AP1000 Structural Design NRC Meeting December 15 - 17, 2003

Open Items from October Meeting

Open Items from October Meeting (continued)

Vertical Floor Response Spectra of ASB Node at EL. 116.50'

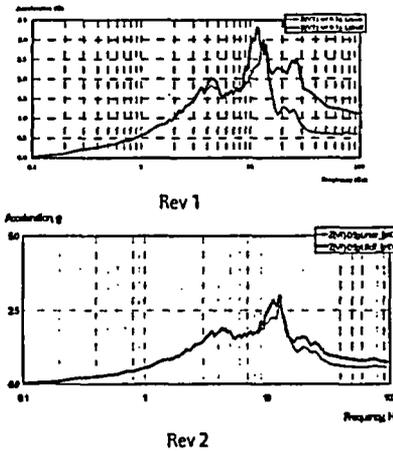
Open Item 19A.2.8 Nuclear island uplift

- Analyses updated since October meeting
- Actual footprint with increased width relative to equivalent rectangle
- Damping increased for RLE
